# USEPA Comments on draft list of topics to address Tetra Tech concerns

December 5, 2016

The Navy has proposed to hire a third party consultant to draft a technical memorandum to outline future Navy work needed to address concerns regarding the integrity of Tetra Tech's radiological cleanup work at the Hunters Point Naval Shipyard. On September 13, 2016, the Navy sent EPA a list of allegations from a former Tetra Tech employee regarding his observations of Tetra Tech past actions to under-represent the actual contamination levels at the Shipyard. Below are EPA comments on the Navy's proposed topics to include in the upcoming Navy evaluation. Working together with both the Navy's Radiological Affairs Support Office (RASO) and Base Realignment and Closure (BRAC) offices through regular conference calls with EPA and DTSC will facilitate an efficient and technically sound process. Sufficient resources should be committed to enable a thorough and timely resolution of outstanding issues identified. The comments below are organized into three parts:

Table 3

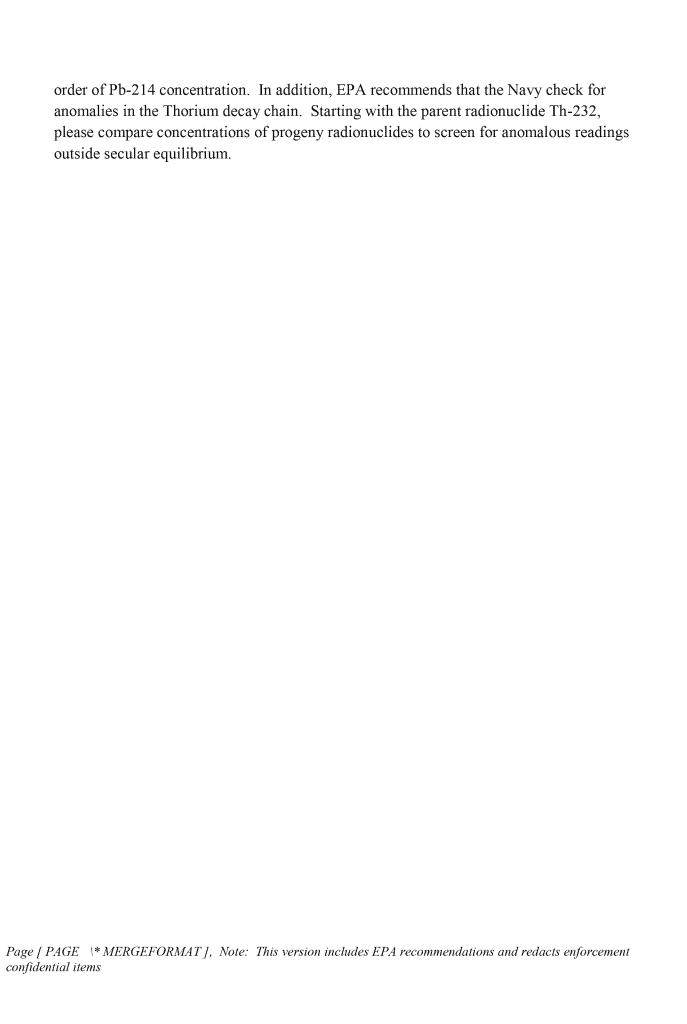
- 5. Allegation redacted
- 6. Discrepancies in the Ra-226 decay chain: EPA found in the NIRIS database that in Parcel B-2, Parcel G, and other areas, Tetra Tech reported in at least 2006, 2007, and 2008 some areas where concentrations of Pb-214 are shown to be higher than Ra-226. In some cases reported concentrations of Bi-214 are also higher than Ra-226. Because Pb-214 and Bi-214 are decay products of Ra-226, this result would not be expected. Many of these discrepancies occurred for samples analyzed by New World Technologies. Please address this finding. Table 3 on the next page shows some examples ranked in
